From: [REDACTED]
To: [REDACTED]
Sent: 2/24/2021 9:16:37 AM
Subject: RE: O8W-PM 35217268, 35224712, 35224713 - Bucks Creek 1101 Phase 1,2&3 - Pre-Engineering Meeting

Subject: O8W-PM 35217268, 35224712, 35224713 - Bucks Creek 1101 Phase 1,2&3 - Pre-Engineering Meeting

PM 35217268 (Phase 1)

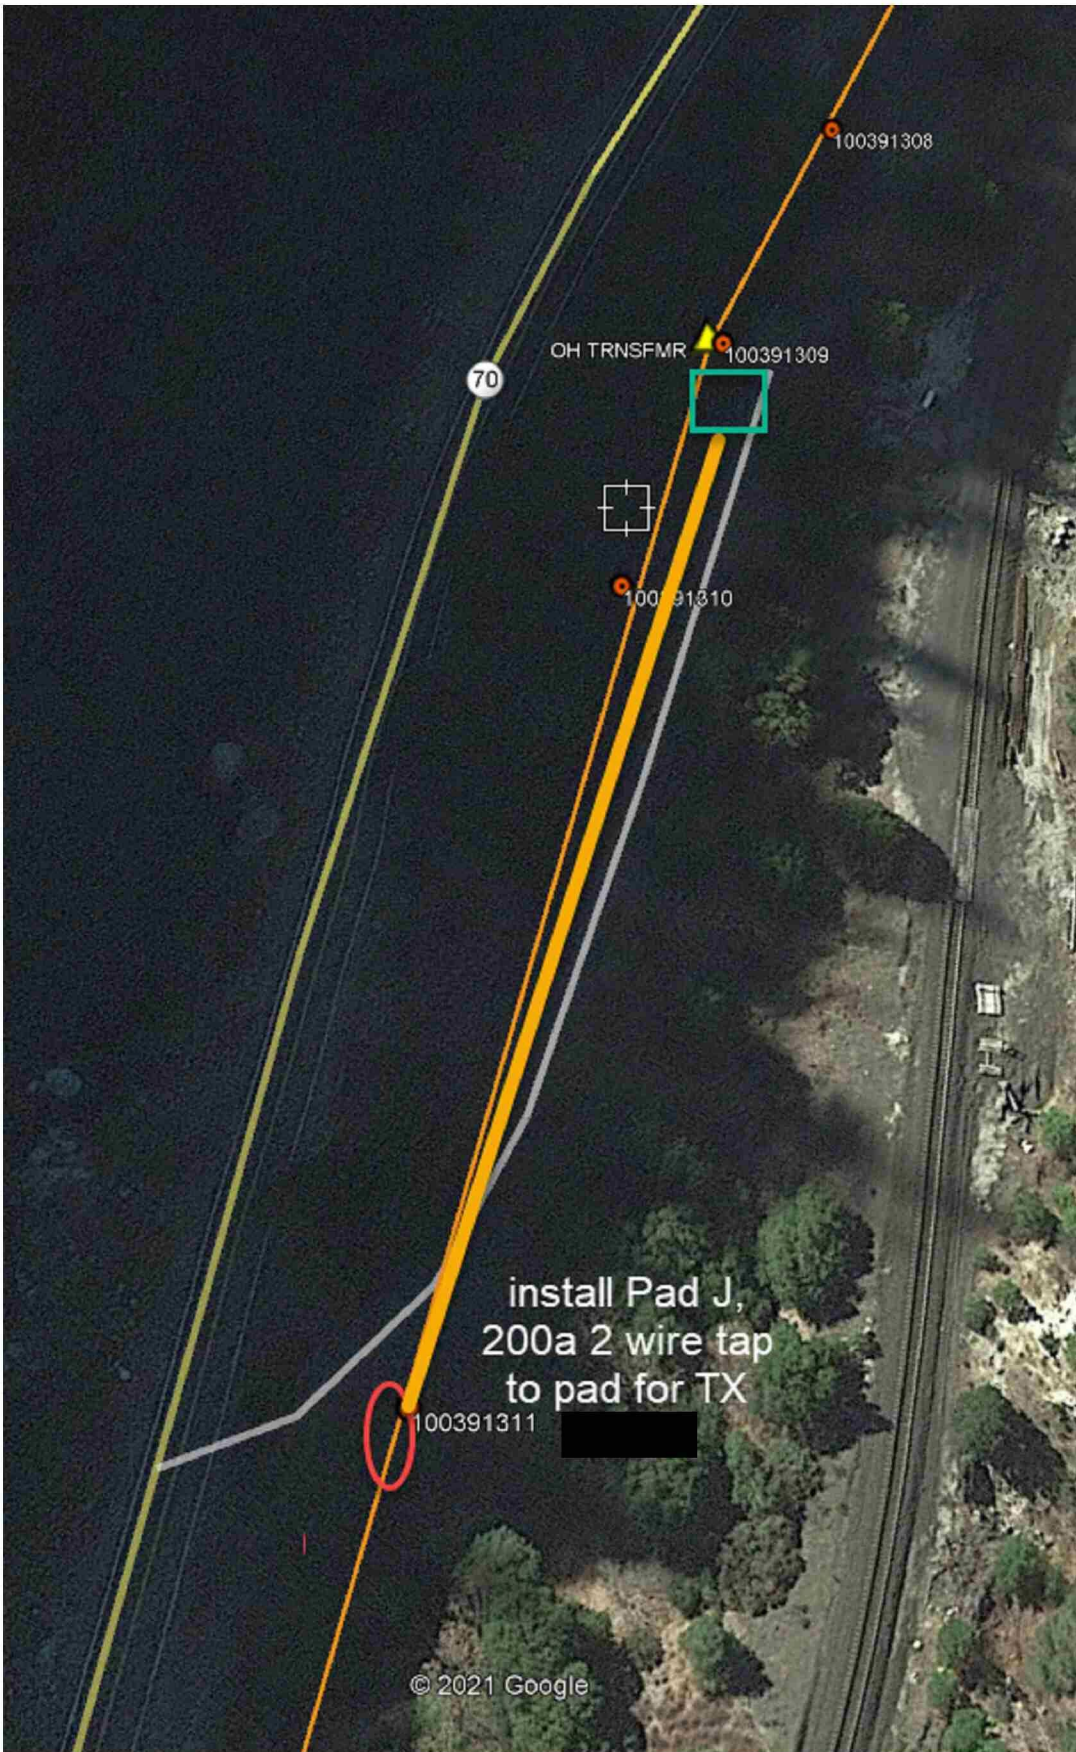
Your outlet red-line Bucks Creek looks close to what I was thinking. Need to work with [REDACTED] to get this designed with a single 6" and use #5 boxes with 200A cable. There is not a reason this will need (2) 6" and 1-4" and 7 boxes. There is probably only 20a peak on the primary now.

Before we involve [redacted] and [redacted] it would be good to scope with the estimator so we can address the local folks with a somewhat solid plan. If we can establish the outlet for Bucks Creek Sub + the TX locations for Cresta Dam and [redacted] that should take most of the questions away. Rock Creek Bridge is the only thing I saw a big issue with. The local guys can help us once we determine what we are doing and make sure we get the details correct for permit.

Also need to see what Hydro is willing to do with the TX for the penstock metering valve at Rock Creek PH. It will be a long way up from the

Need to see if Hydro has GPR data for the Hwy 70 road bed to see if we can get 42" minimum cover and keep clearance over any hydro facilities.

Rock Creek

Merlin can go back like we just did [redacted] Poe. Pad on the Highway and tension secondary 1/0 ASCR across the river. We can negotiate to move the [redacted] service point with my MSA electrician.

we can serve [redacted] Merlin with either circle, OH 1/0 ASCR triplex tension across the river.

Cresta Dam

Should be able to take a pad here and get the dam a UG service. For [redacted] riser up and go in the back of

the first tunnel window, leave the old TX pole, top it and use to splice in UG service feed.
